DR-R18-0001 Saratoga Retail Appeal Hearing(s) Legistar 18-1497 and 18-1498

The El Dorado Hills Area Planning Advisory Committee would like to include this public comment letter and accompanying attachments for consideration of the Board Of Supervisors in regards to their Tuesday October 9, 2018 BOS Meeting Agenda Items 40 & 41 (18-1497 & 18-1498) - hearings appealing the Planning Commission's August 23, 2018 approval of Design Review Revision DR-R18-0001/Saratoga Retail Phase 2.

The El Dorado Hills Area Planning Advisory Committee (“EDHAPAC”) would like to offer these comments to be included in the public record, prior to your consideration of the two appeal requests of the Planning Commission’s August 23, 2018 approval of Design Review Revision DR-R18-0001/Saratoga Retail Phase 2.

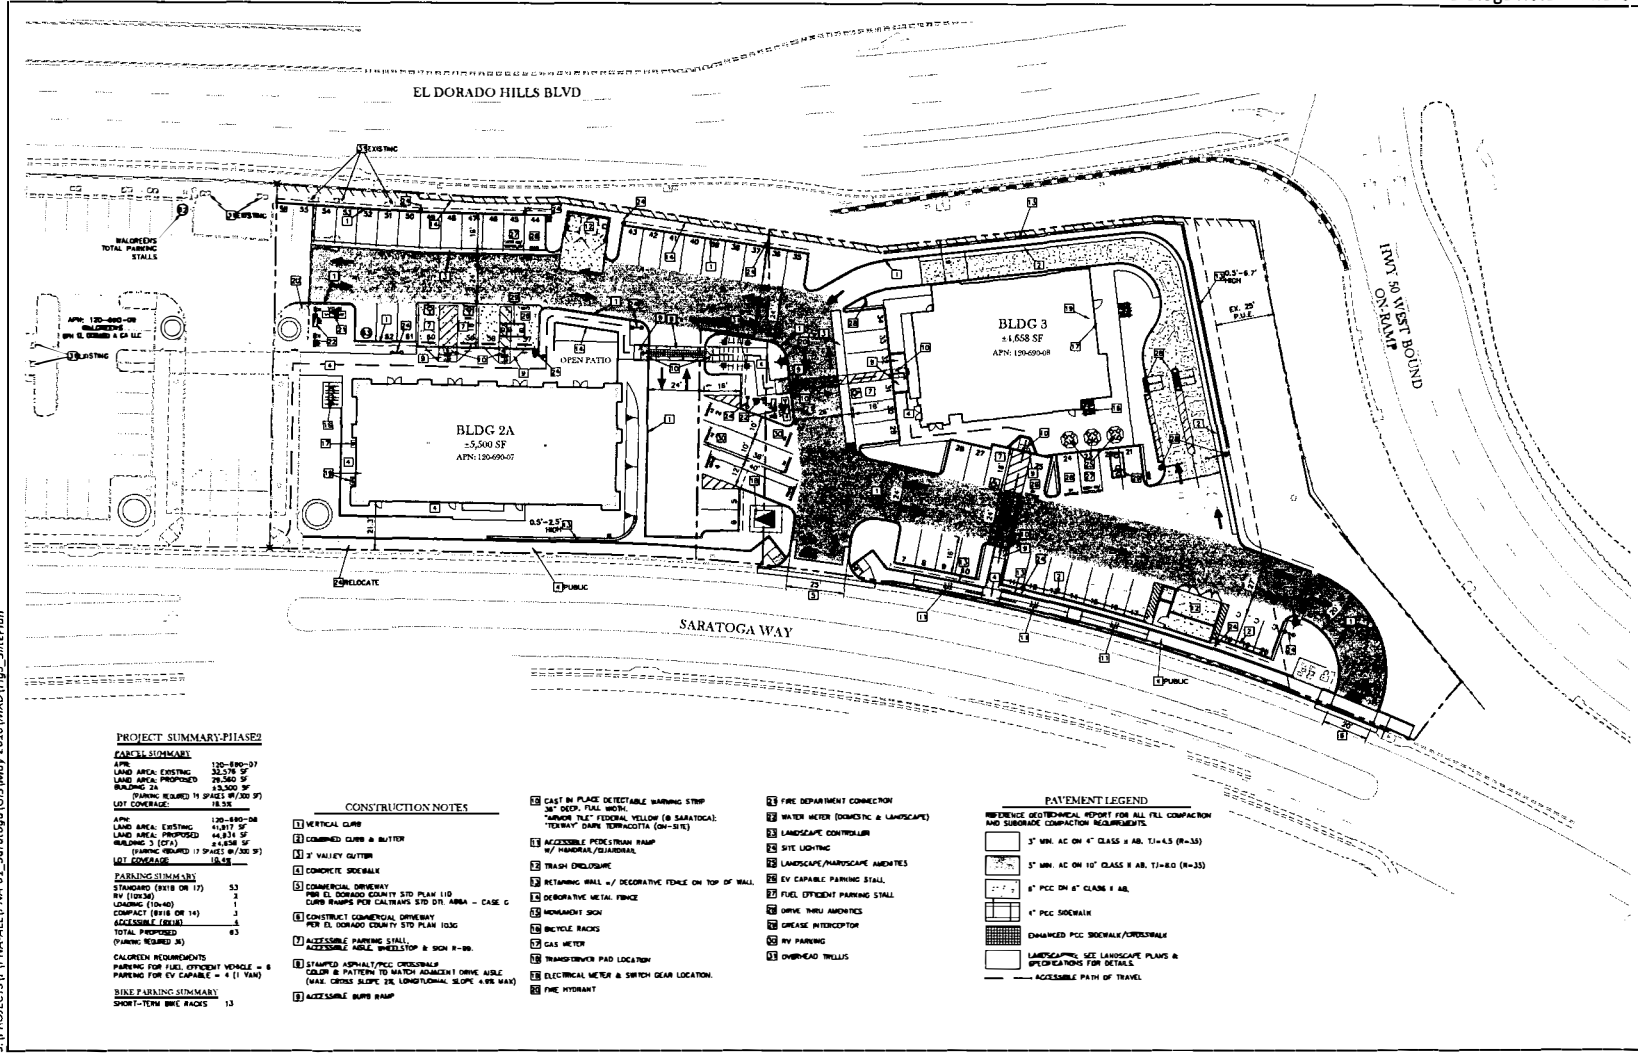
Scrutinizing the Helix design "Site Plan, Figure 3" (attached) the project allows for 24' widths between rows of cars, landscaping etc on the design. There is a gutter behind the row of cars adjacent to Bldg 3 that appears to add two feet, so in that area it can be assumed the pavement measurement for a right turn is **26' - 28'**. Add a few more feet from the pedestrian walkway in the middle and it is still not enough feet for large vehicles, especially ones with trailers to navigate these turns.

Please take a careful look at the diagrams and try to understand how the configuration for loading and RV and trucks with trailers will work in a real life scenario, especially with inexperienced RV drivers.

What will happen is that people will park their RV's on Saratoga Way and then leave the road by taking Arrowhead to Mammoth and turn left onto Saratoga. But when Mammoth becomes a right turn only, the vehicles will be forced to loop back the same way they came and either continue on Saratoga to Iron Point (once it is connected) or, if they are heading east toward Tahoe, drivers will again take a right turn onto Arrowhead (if the turning radius allows if there are no cars parked on the street) and then drive up into a residential neighborhood to and figure out how to get out. When Saratoga becomes a four lane with a raised median, the scenario for Park Village Residents becomes even worse. We will have multiple transient RV's parking right in front of our homes!!! Imagine people pulling out lawn chairs and eating chicken burgers in front your house.
